**DOCUMENT 00 90 00  
ADDENDUM**

**ADDENDUM NO. [3]                      Date: November 20, 2018**

**RE:                      GLENWOOD COMMUNITY SCHOOL DISTRICT  
ATHLETIC COMPLEX IMPROVEMENTS BID PACKAGE 2 REBID  
400 SIVERS ROAD  
GLENWOOD, IOWA 51534  
HSR PROJECT NO. 18005**

**4** BUILDING SECTION  
1/4" = 1'-0"

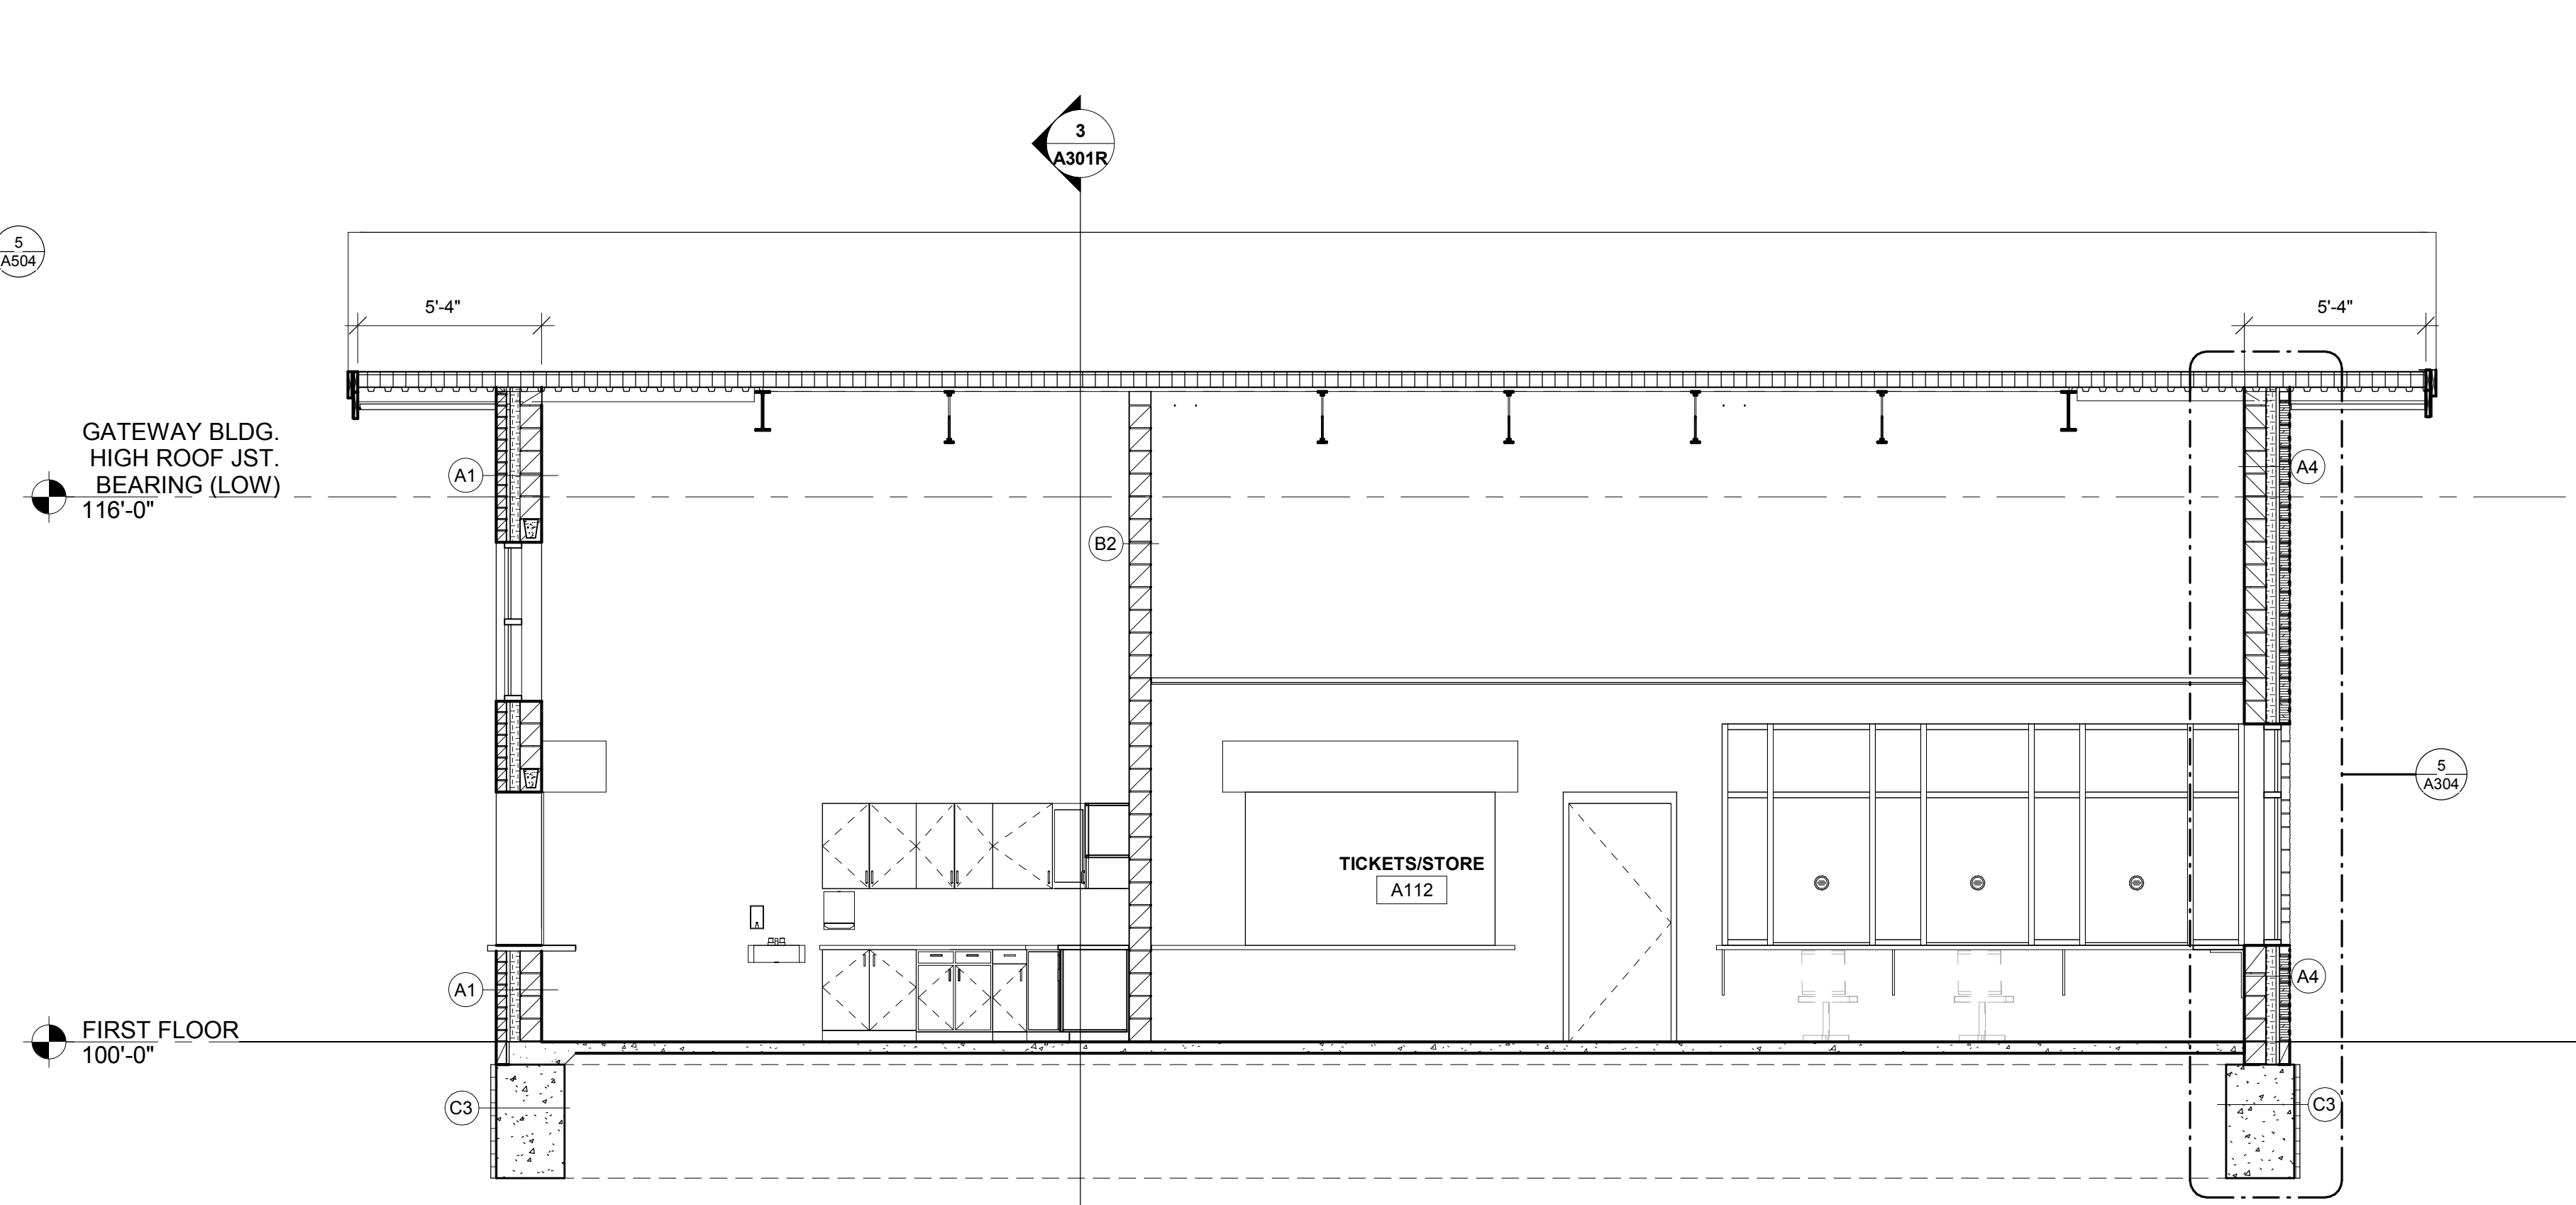
15. Sheet A301R GATEWAY BUILDING SECTIONS 30 x 42 Drawing attached hereto
  - a. Revisions clouded on Drawing.
  - b. 4A301: Overhang should be the same as 15S300; 5'-4" overhang from inside face of CMU.

**2 BUILDING SECTION**  
1/4" = 1'-0"

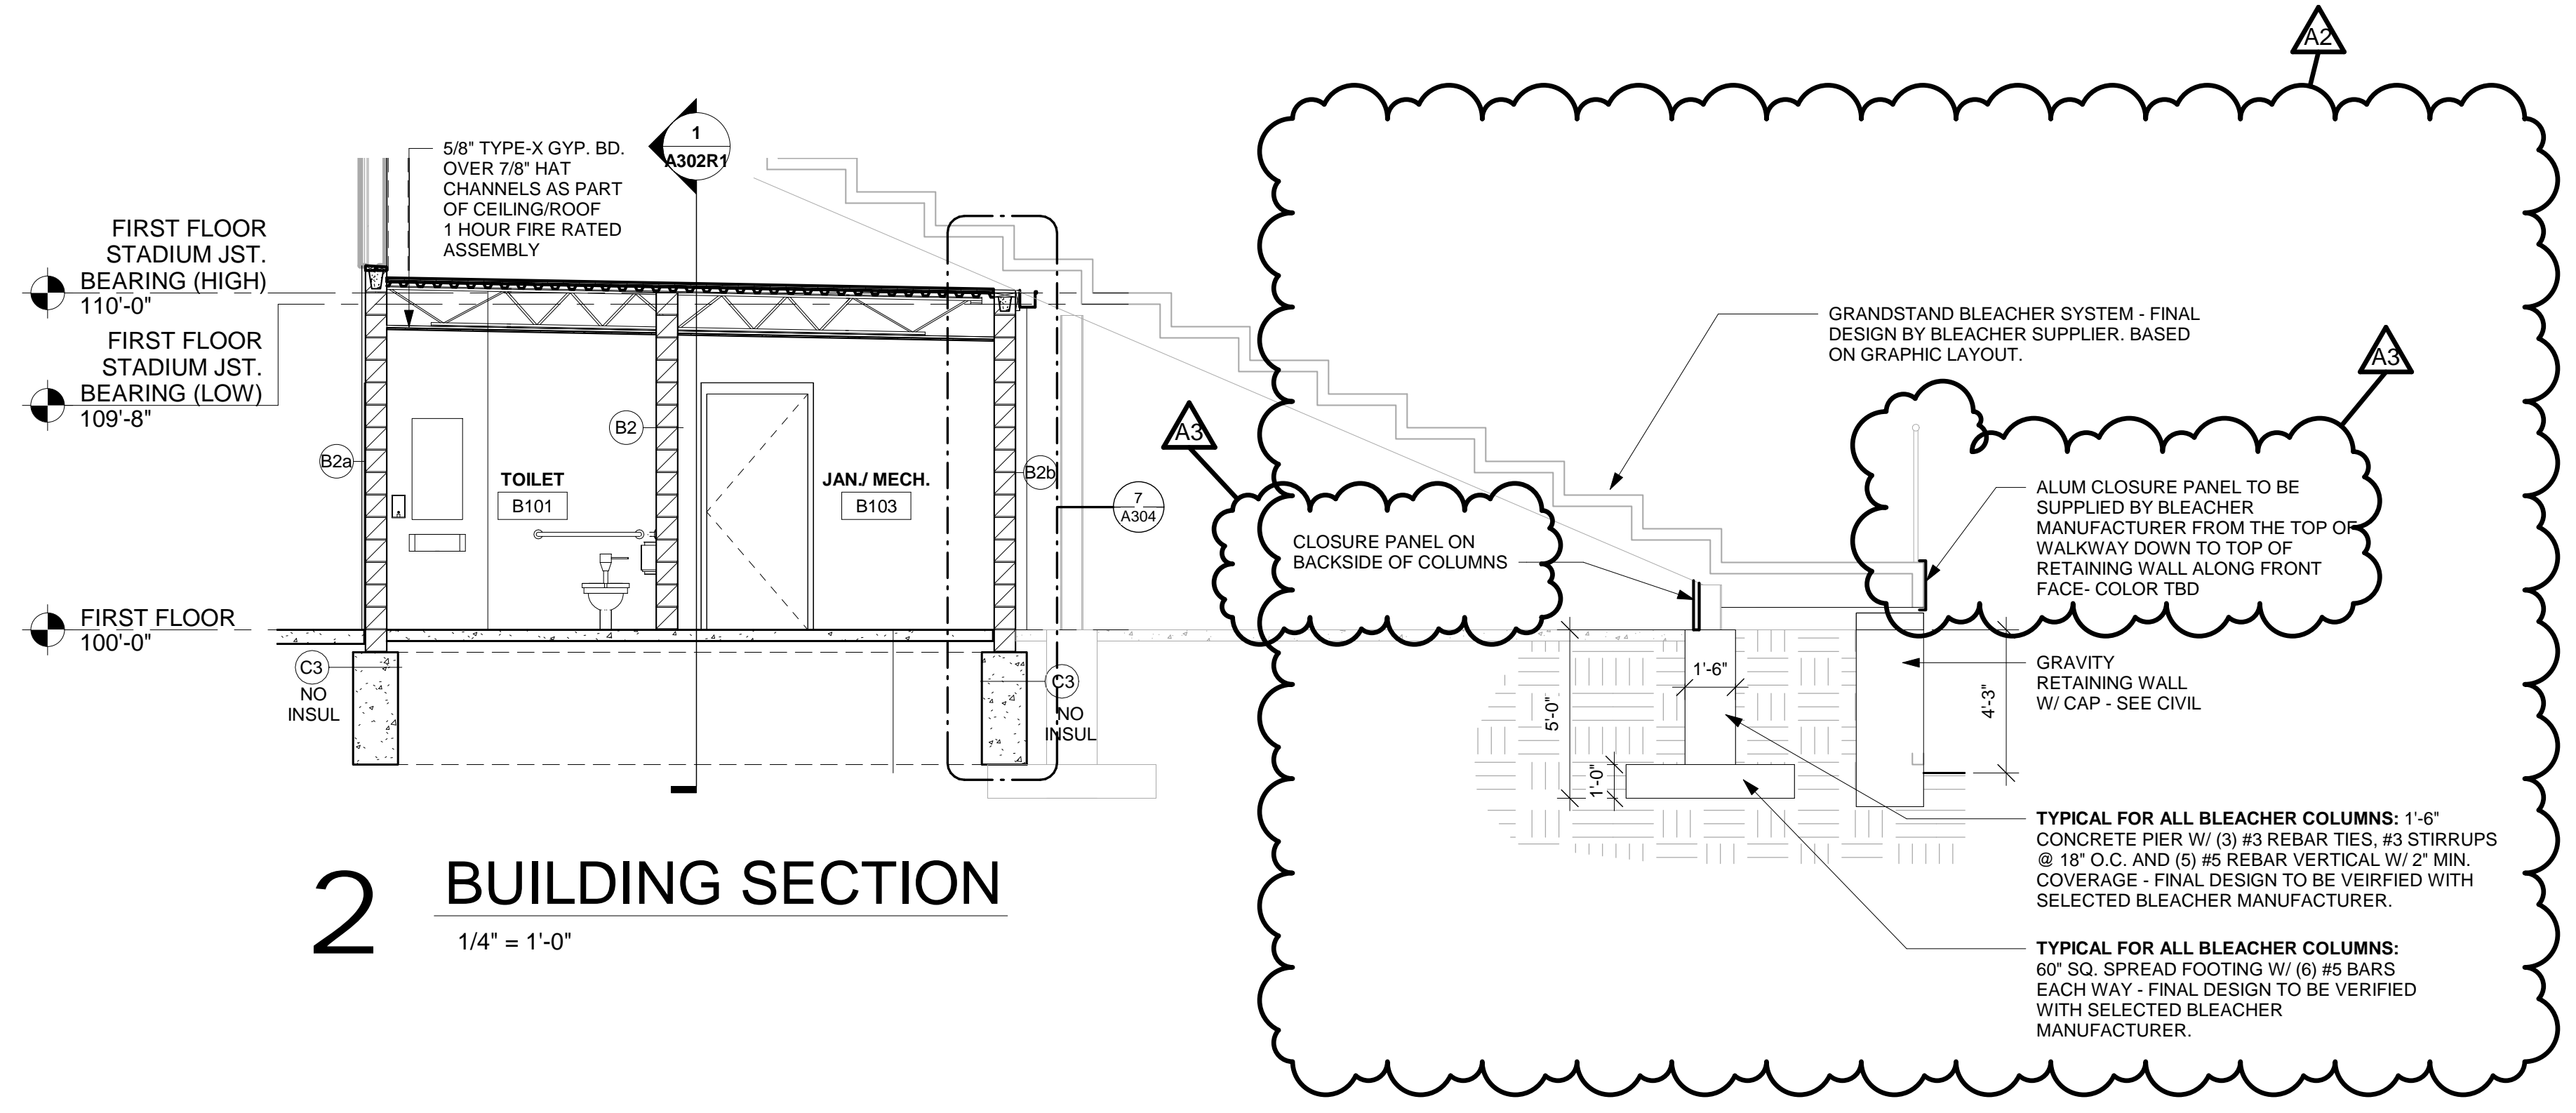
2. Sheet A302R1 FIRST FLOOR STADIUM BUILDING SECTIONS 30 x 42 Drawing attached hereto. (Replaces A302R from Addendum 2.)
  - a. Revisions clouded on Drawing.
  - b. 2A302R1: Install a closure panel along the bottom inside of bleachers from column to column to close off underside completely. Provide intermediate support verticals as required between support columns.
  - c. The footing/foundation design shown may vary by supplier requirements. Final requirements and quantities shall be verified with grandstand supplier.
